Change Order - Construction Manager-Adviser Edition

PROJECT *(Name and address):*
Seven Oaks Elementary School
District 5 of Lexington & Richland Counties
1020 Dutch Fork Road
Irmo, South Carolina 29063

CHANGE ORDER NUMBER: 001
INITIATION DATE: July 20, 2010

Subject: Sewer line & tree root conflict

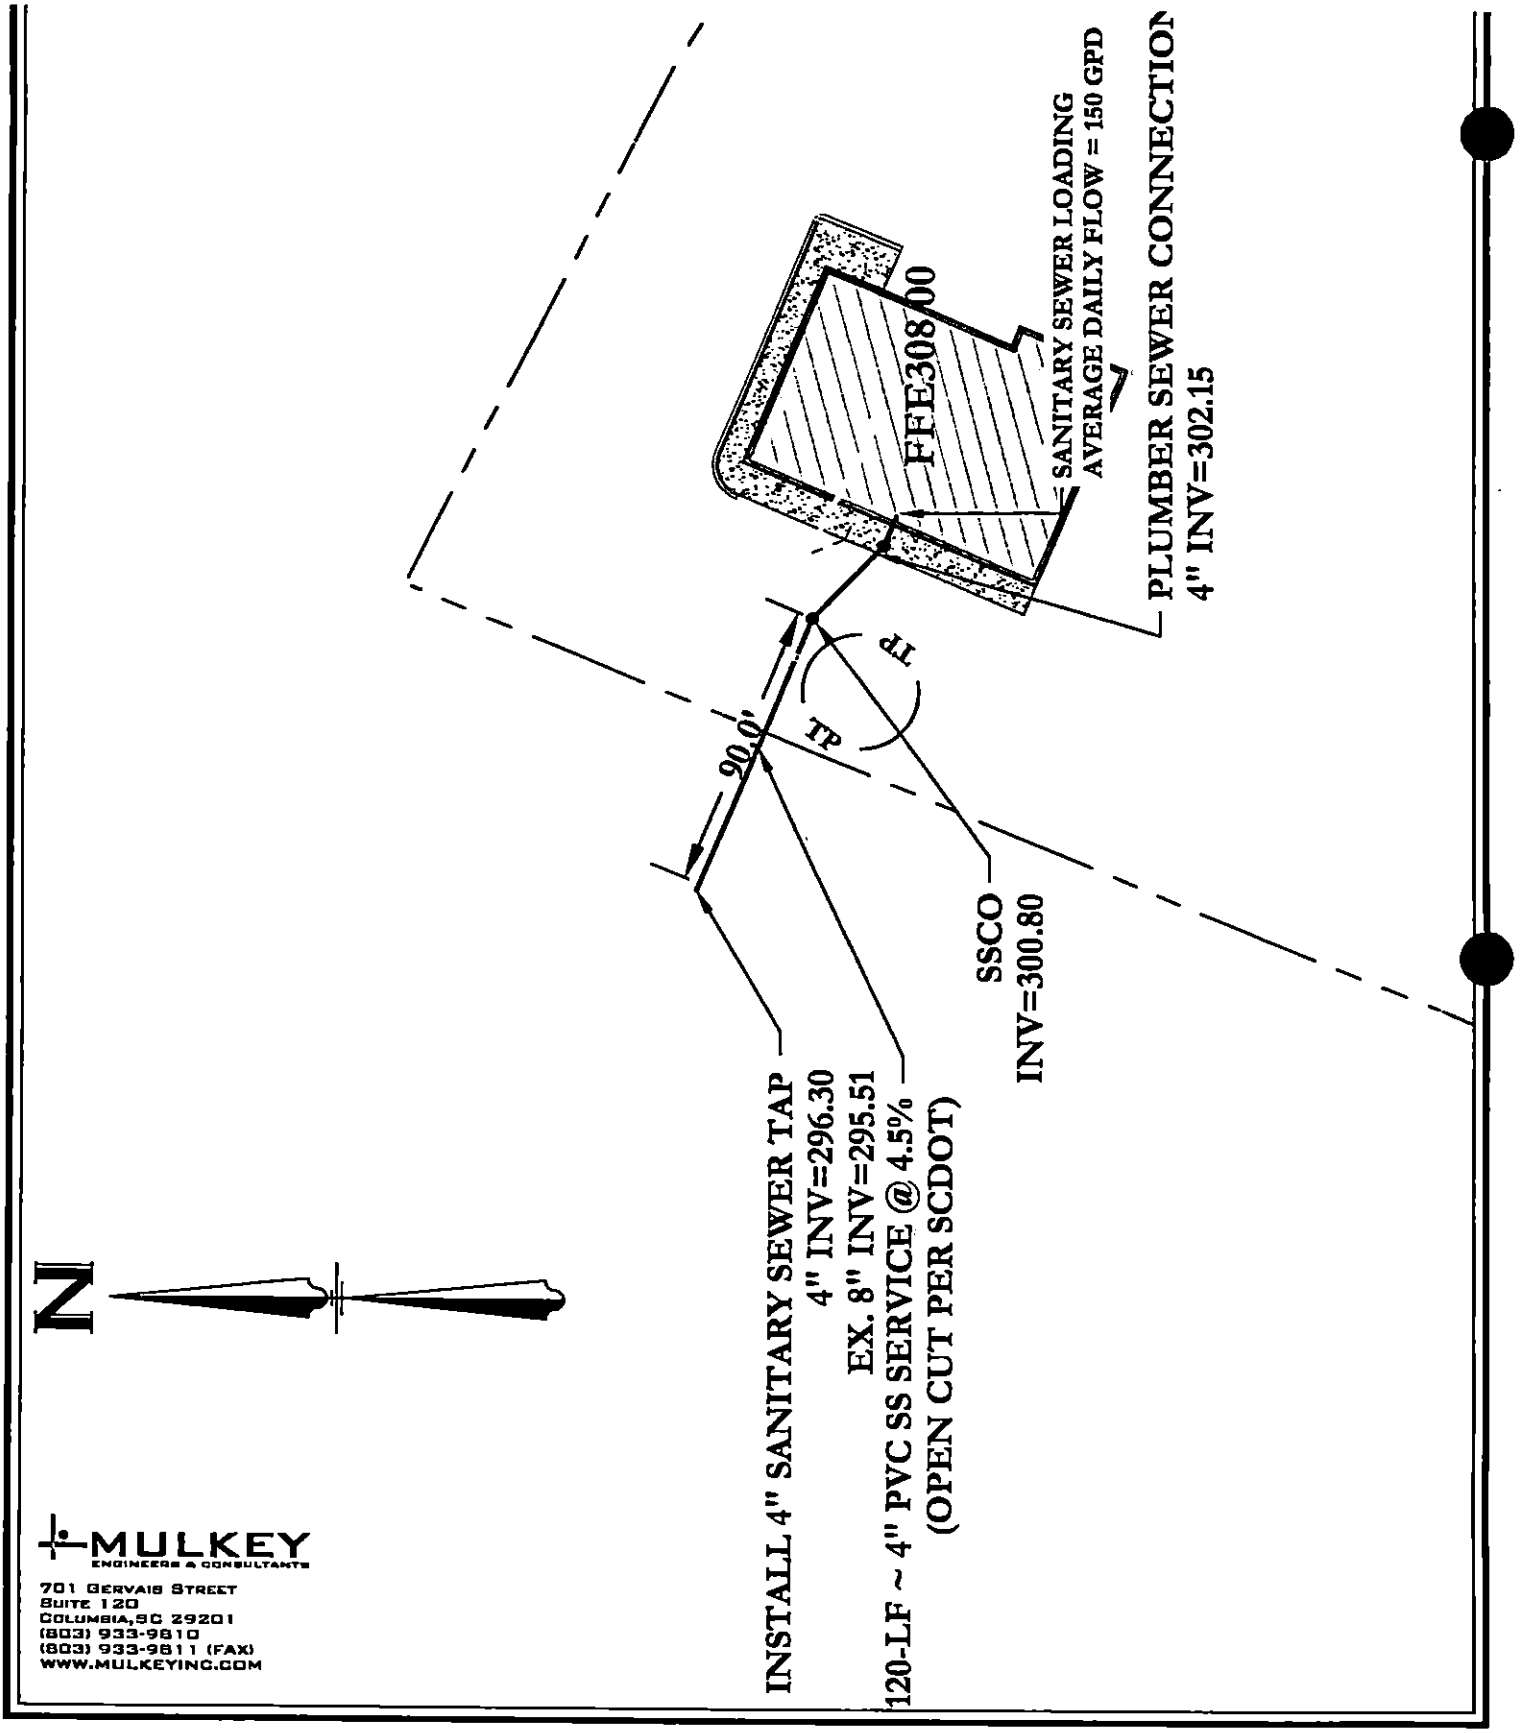
Question/Problem/Clarification:
Conder Construction's arborist noted in the tree protection submittal that there was a conflict between the new administration building sewer line and the critical root zone of one the large oak trees along Ashland Road. Is this sewer line going to be rerouted to avoid the tree's roots?

Additional Wardrobes

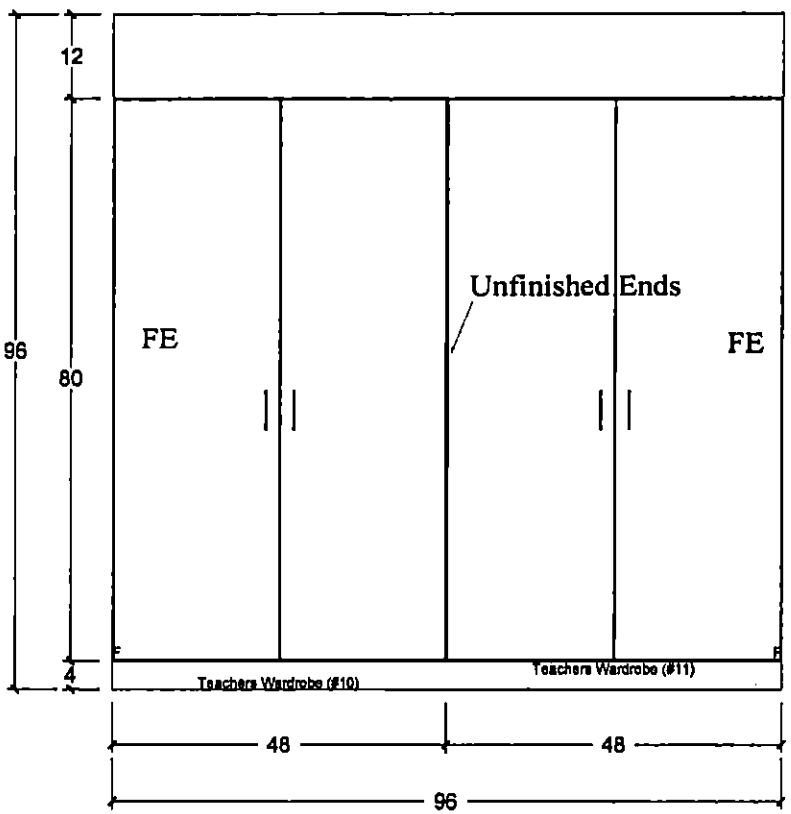
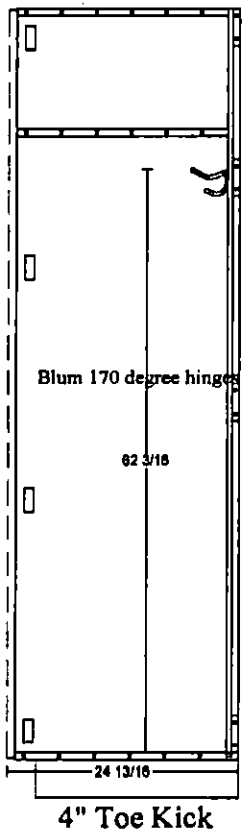
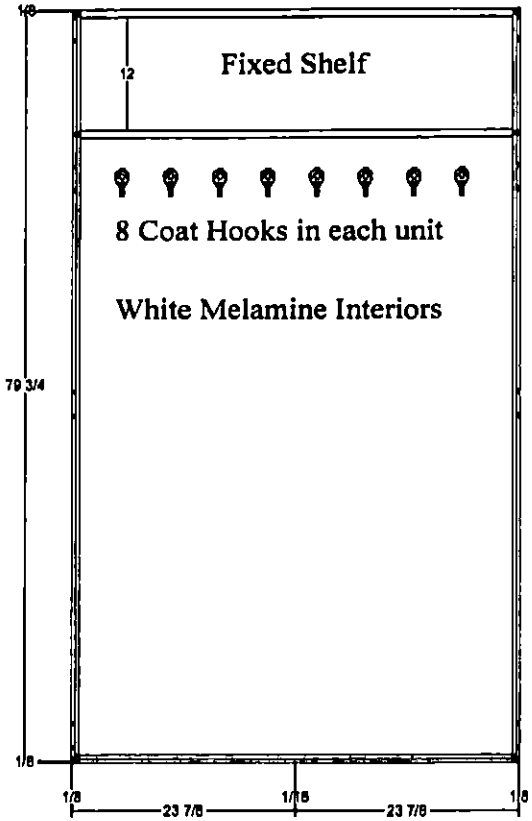
Description	Material	Labor	Sub & Misc
1	Unit pricing to provide and install dual		32	1,150
	station wardrobe designated LSI-5142			
	with one fixed shelf, 16 double coat			
	hooks, and finished end on one end			
	per Carolina Woodcraft 3.9.11 quote			
	and LPA SKA-014 detail 3.			
2				
3				
4				
5				
6				
	Subtotal	$ -	$ 32	$ 1,150
	Sales Tax @ 7.00%	$ -	----	----
	Subtotal	$ -	$ 32	$ 1,150
	O. H. & Profit @ 15% 7.0%	$ -	$ 5	$ 81
	Subtotal	$ -	$ 37	$ 1,231
	Bond @ 1.44%	$ -	$ 1	$ 18
TOTALS		$ -	$ 38	$ 1,249

CO #68 revised per Chris Farr request to provide quote to only finish one end of each cabinet, since school district determined that two units will now be installed side by side in four different classrooms in phase 5 and not as stand alone units previously priced.

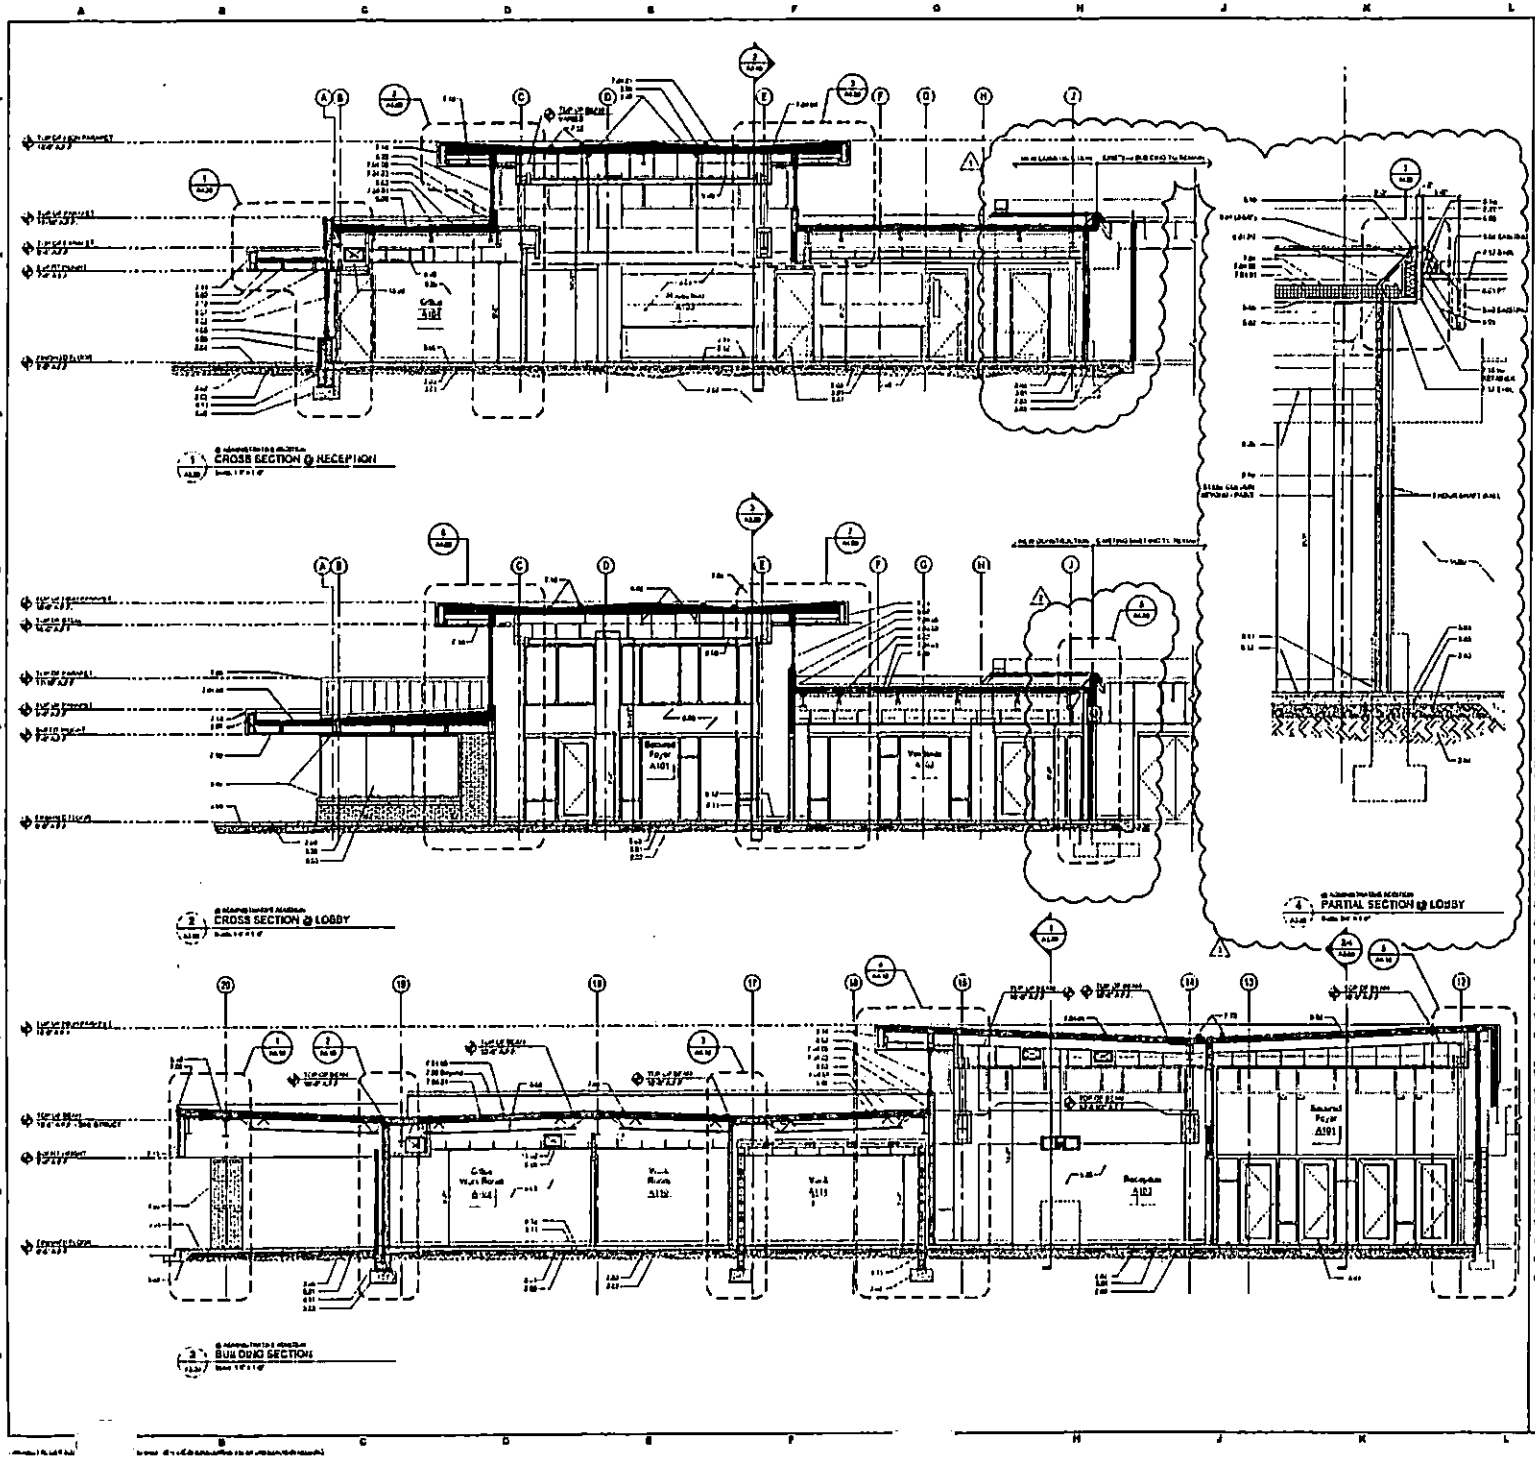
AD1.01 shows that the masonry walls around the existing electrical room (between the cafeteria and multipurpose room) to be demolished. These walls support joists and beams that support the canopy which we are to remove, but also portions of the roof in the existing cafeteria. (School was in session, so I was unable to take pictures from the interior of the building.) Please advise on how what needs to be done to provide support to the portions of the existing roof that are to remain intact. (Pictures emailed separately-C.Farr)

Please find attached - revised drawings A3.00, A4.00, A5.00, A5.01 - Structural Sketches SK-S010, SK-S011 - Blaze-Shield II - Roof assembles - Protected Deck - UL P826 DN

A5.00

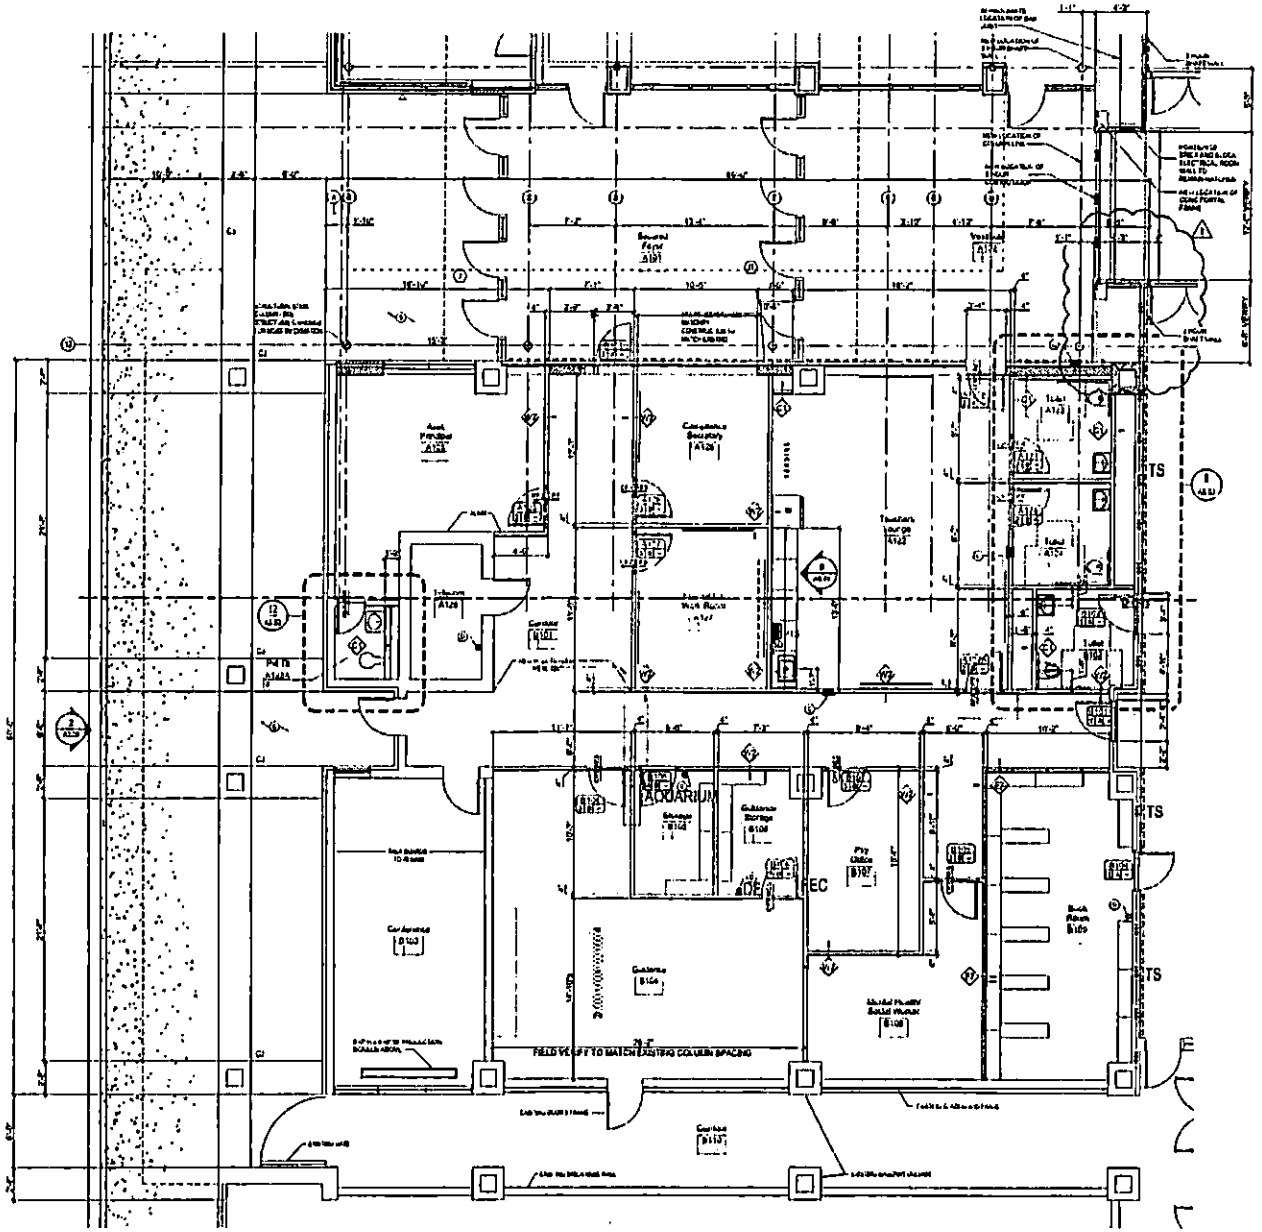
Add metal stud partition and install hollow metal window frame in the Office Admin area per Revised drawing page A5.00 Add ***$1,870.00*** *to original contract amount.2-extra days will be required to perform this extra work.*

Subject: Restroom C106C Clarification

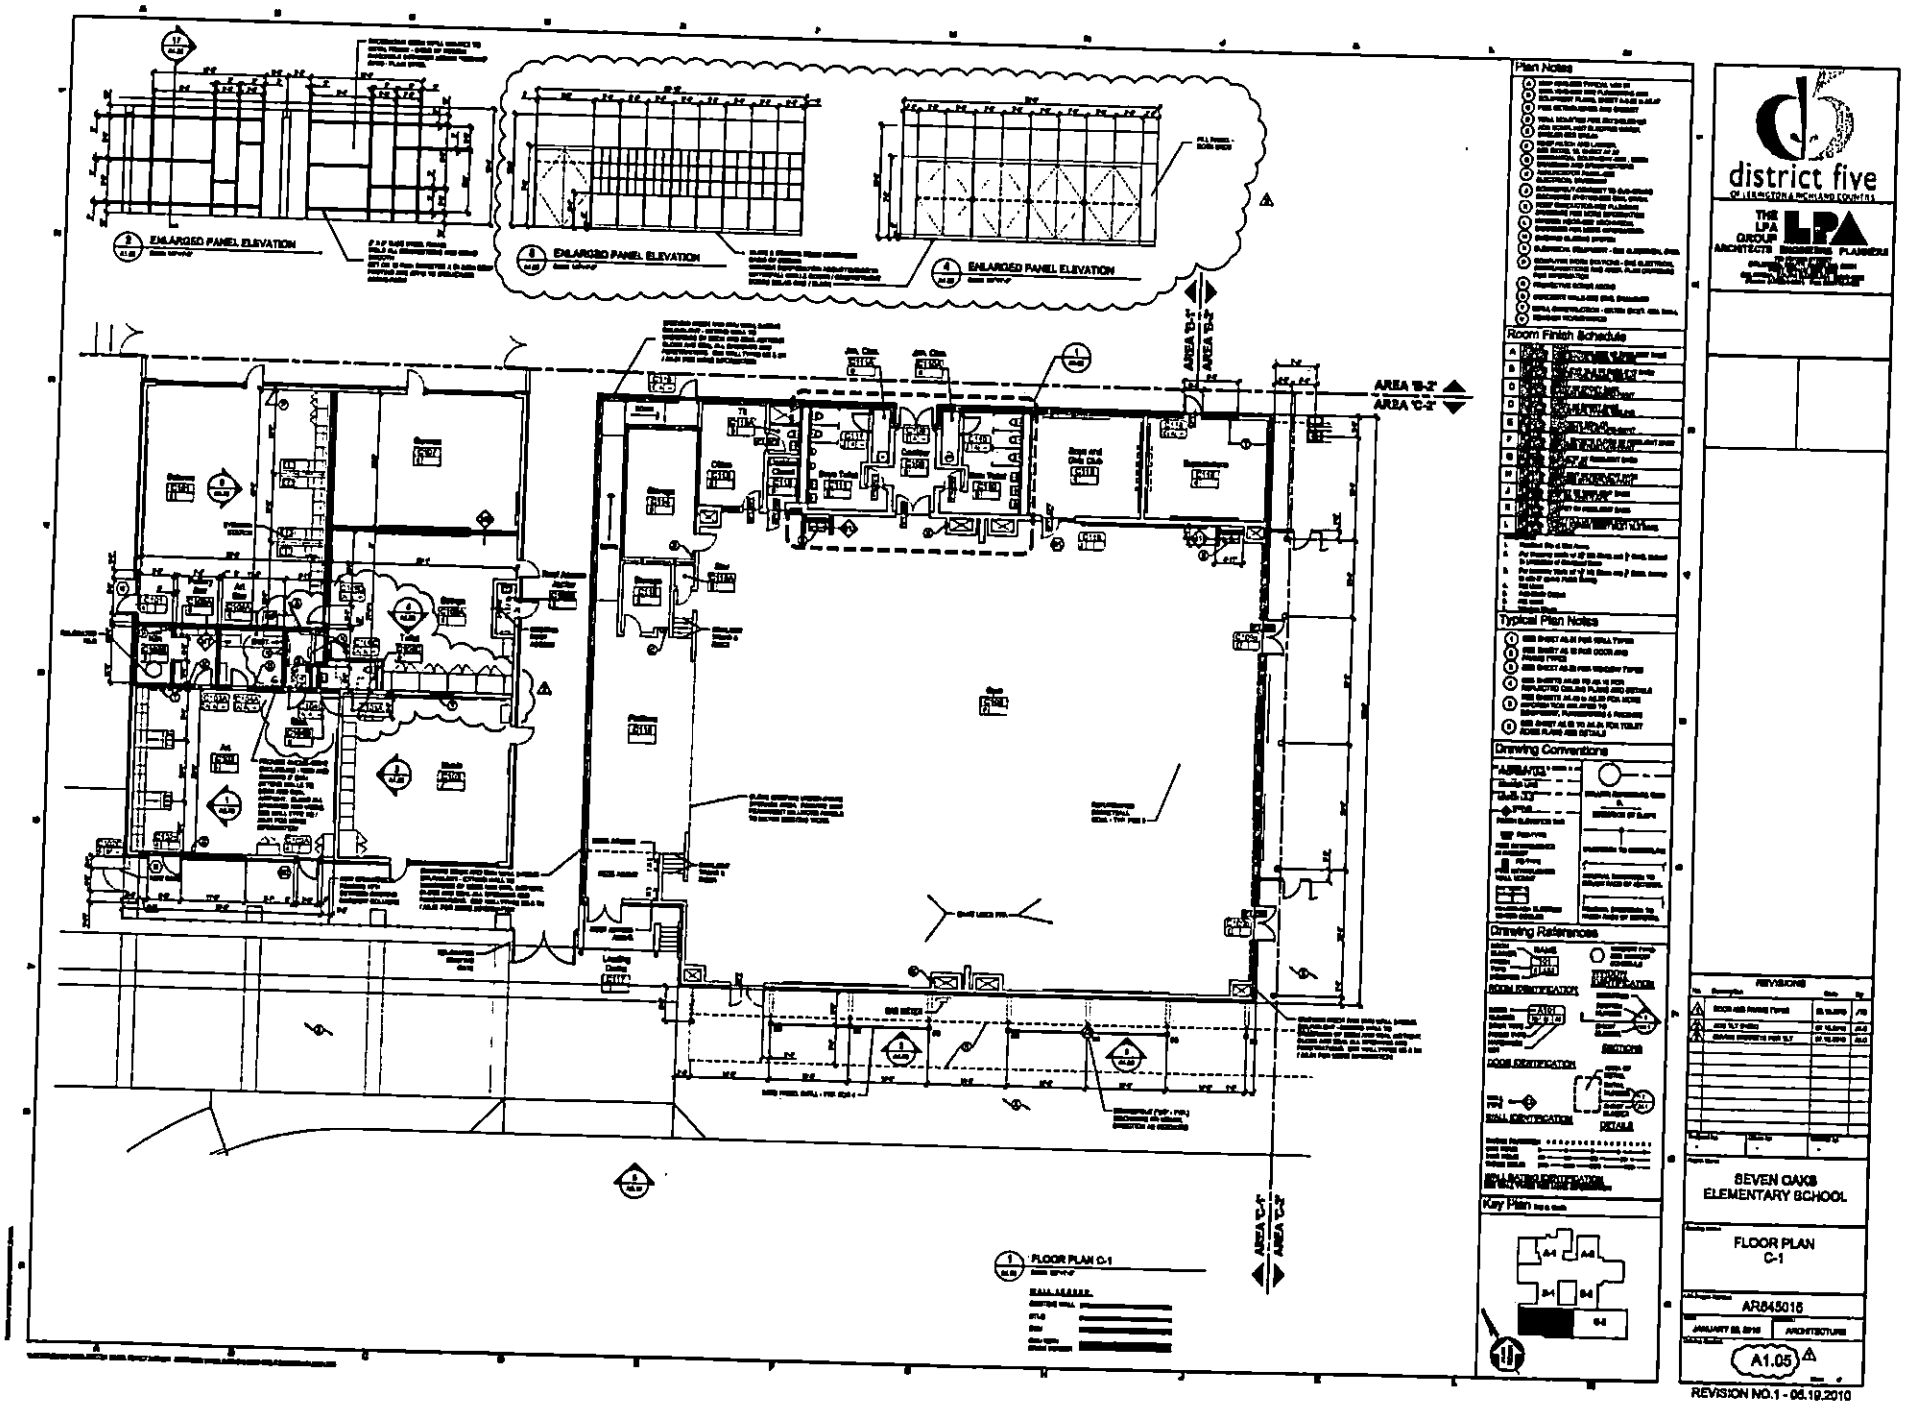
Question/Problem/Clarification:
Revision 1 of sheet A1.05 showed the installation of a new restroom in phase 6. The mechanical, plumbing and electrical contractors have requested verification on their respective components which will need to be installed in this new room, i.e. model numbers for the fixtures, circuits that lights/fans are to be fed off of, exhaust fan model, etc.

See attached LA documents for plumbing/HVAC layout. Refer to electrical engineer for any electrical requirements.
